## Addendum No. 1

City of Coquitlam

RFP No. 25-064

### Public Safety Building - Operational Communications Centre Desks

**Figure 1**

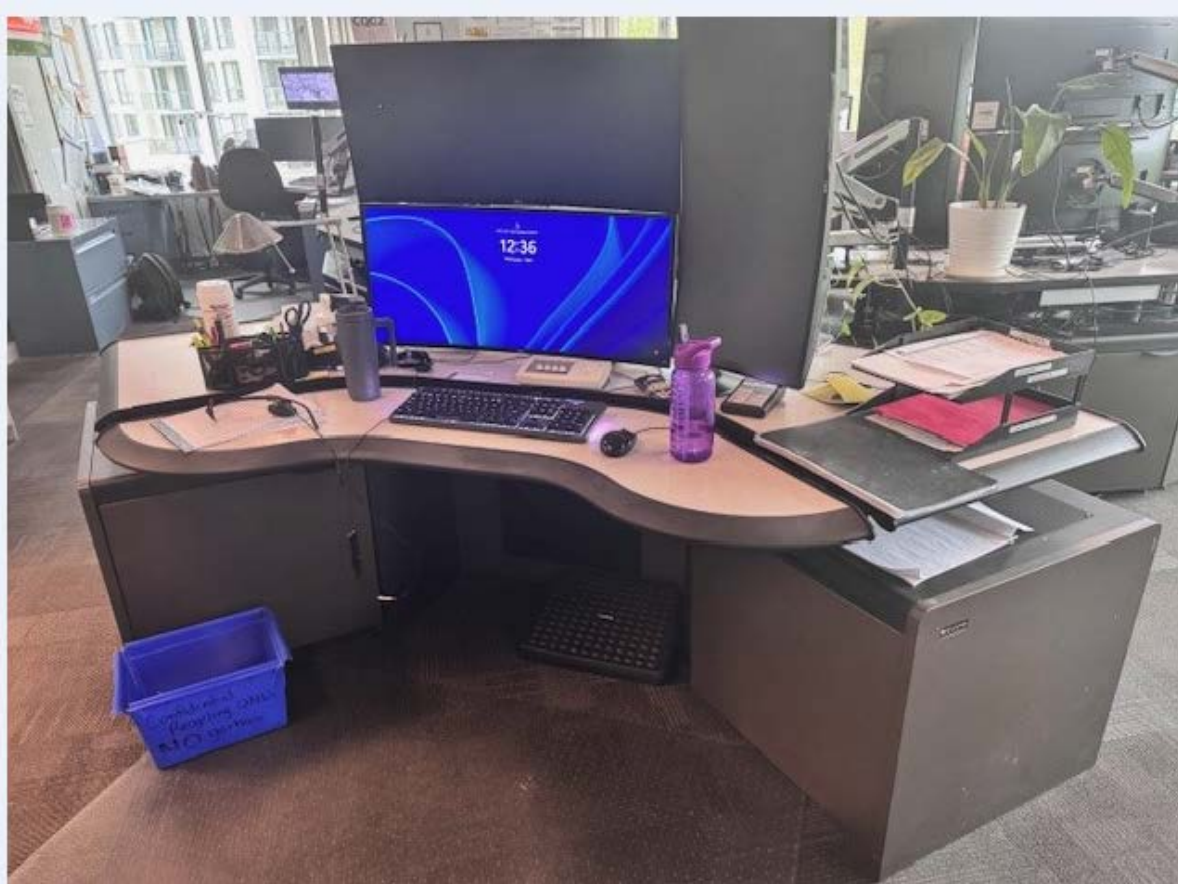
Q10. Describe the structure of the existing desks (wood, metal). Can you provide the make and model? This will aid us in understanding recycling requirements. Can you provide any pictures of them?

**A10. Existing desks are Evans consoles Wood/metal, model unknown purchased approx. 2007/2008. See Figure 1 and 2.**
